## ***Interactive comment on “Characterization of the Particle Emission from Ships Operating at Sea Using Unmanned Aerial Vehicles” by Tommaso F. Villa et al.***

Response to Reviewers Comments: Title: Characterization of the Particle Emission from Ships Operating at Sea Using Unmanned Aerial Vehicles Authors: Tommaso F. Villa, Reece Brown, E. Rohan Jayaratne, L. Felipe Gonzalez, Lidia Morawska, Zoran D. Ristovski The authors thank the Reviewer for the \ comments, and they have modified the manuscript to address them. Reviewer #1: Comment 1: Line 22: There is a typo with the first emission factor given. Answer 1: The typo in the text of the manuscript has been corrected. Line 22 Comment 2: L24: The authors indicate that they have demonstrated a “reliable, inexpensive and accessible” way of measuring ship emissions. The

Fig. 2. Figure 5

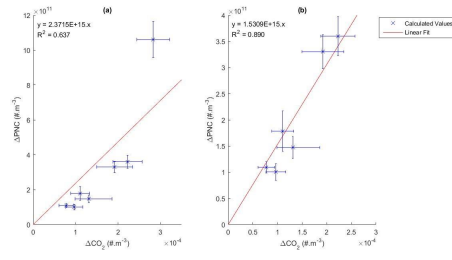
Comment 7: Table 2 and Fig. 5: The units given for CO<sub>2</sub> are not correct. This must be kg/m<sup>3</sup>. It is not possible to simply have kg as the units, since the volume is not known. Also, if the units are not kg/m<sup>3</sup>, then the units on the derived EFs will not make sense.

Comment 8: Table 2 vs. Fig. 5: There seems to be an inconsistency. The slope from Fig. 5 can be converted to an EF by multiplying by 3.2 kg CO<sub>2</sub>/kg-fuel. This yields 6.4e15 particles/kg-fuel. But, the average from Table 2 is only 2.6e15 particles/kg-fuel. These should be closer. The difference may be because the authors have not fixed their intercept to zero. This should be looked at by the authors. Also, in Fig. 5 the x-axis should start from zero.

Answer 7: The authors thank the Reviewer for the comment. The claim has been addressed in the manuscript and both Table 2 and Fig. 5 have been corrected.

Answer 8: The authors have considered the Reviewer’s comment. In the new methodology the final EFPN is calculated using the slope of the line with the intercept fixed at zero as recommended here. The axis has also been updated to start from origin.
